From: BRYAN Martin (EXTERNAL AREVA) [Martin.Bryan.ext@areva.com]
Sent: Wednesday, September 15, 2010 5:48 PM
To: Tesfaye, Getachew
Cc: DELANO Karen (AREVA); ROMINE Judy (AREVA); BENNETT Kathy (AREVA); NOXON David (AREVA)
Subject: Response to U.S. EPR Design Certification Application RAI No. 392, FSAR Ch. 11, PHASE 4 RAI, Supplement 2
Attachments: RAI 392 Supplement 2 Response US EPR DC.pdf

Request for Additional Information No. 392(4650), Supplement 2

U.S. EPR Standard Design Certification

SRP Section: 11.05 - Process and Effluent Radiological Monitoring

Figure 11.05-21-1—Pre- and Post-Failure Total Airborne Particulate Concentration at the Radiation Monitor Sampling Location¹

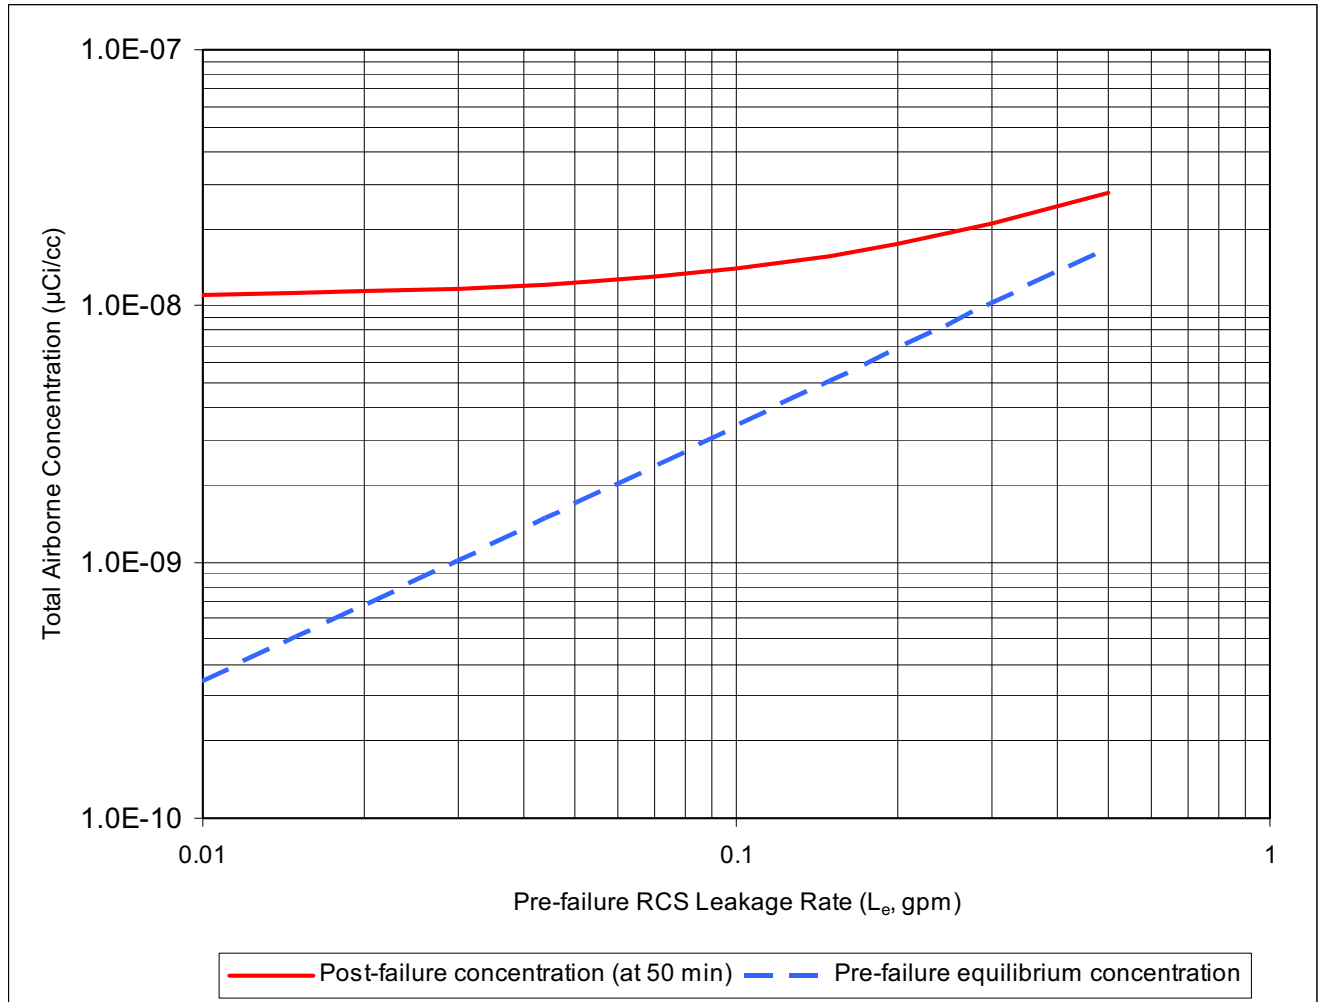
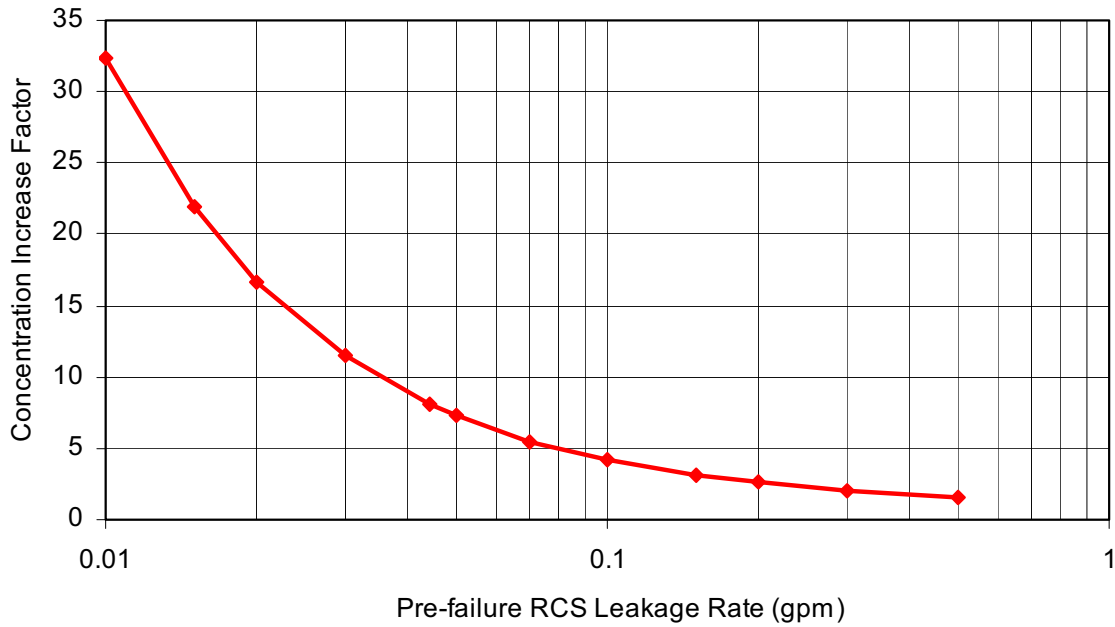
1. Figure 11.05-13-1 presented in the response should be expanded to include in the right ordinate axis, the derived dynamic response range of the instrumentation showing where the 1 GPM criterion would be met.

The Response to RAI 276, Question 11-05-13, Supplement 2 indicated that U.S. EPR FSAR Tier 2, Figure 11.05-13-1 would be revised to include, in the right ordinate axis, the derived dynamic response range of the instrumentation showing where the gpm criterion would be met. However, this is not feasible. The dynamic response of the monitor is relative to the pre-existing airborne activity and the associated background radiation level. The alarm setpoint will be established as a multiple of the background radiation (at least a factor of two). Therefore, the dynamic response is characterized as a multiple of the pre-existing activity. For example, if the pre-failure leakage rate is 0.1 gpm, which implies that the post-failure leakage rate would be $1 + 0.1 = 1.1$ gpm, the increase of airborne concentration within 50 minutes occurs by a factor of 4.14 (see Table 11.05-21-1).

A new figure (Figure 11.05-21-1) was developed to show the pre- and post-failure total airborne particulate concentration at the radiation monitor sampling location as a function of pre-failure reactor coolant system (RCS) leakage rate assuming a realistic reactor coolant activity concentration. The post-failure RCS leakage rate is 1 gpm higher than the pre-failure value (see U.S. EPR FSAR Tier 2, Section 5.2.5). The ratio of these two plots is shown in U.S. EPR FSAR Tier 2, Figure 11.05-13-1 as a result of the response to RAI-276, Question 11.05-13. This figure is also shown as Figure 11.05-21-2. Tabulation of the plotted results in these two figures is shown in Table 11.05-21-1.
